### CITY OF ALBUQUERQUE

RE: Lot 26 Block 7 Unit 4
5620 Kimberlite NW
Revised Grading and Drainage Plan
Engineers Stamp Date 1/7/2022 (E10D110)

Based upon the information provided in your submittal received 1/7/2022, this plan is approved for Building Permit.

LOT 16 BLK 2 UN 2 VC **ENGINEER'S** 5620 KIMBERLITE DRIVE NW GRADING AND DRAINAGE PLAN

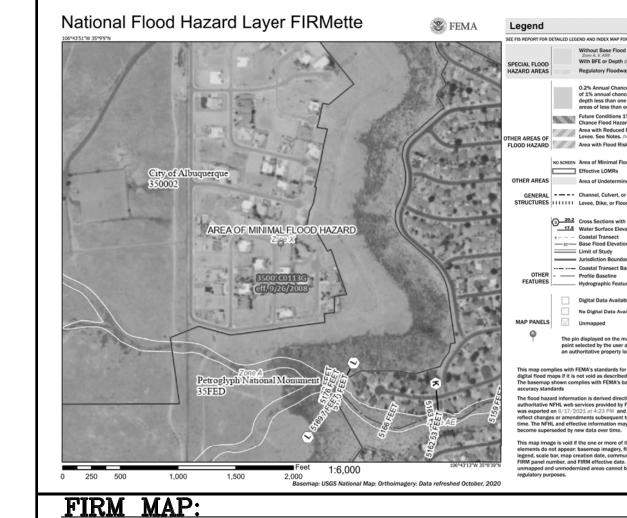
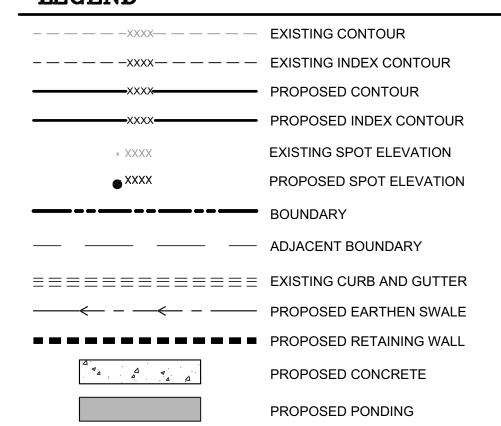
Reiterate to the Owner/Contractor that a separate permit for a garden/retaining wall must be obtained, with the approved G&D plan. Also, advise the owner/contractor not to use dirt as a ramp to climb the curb. If dirt is used it will cause a delay in permitting.
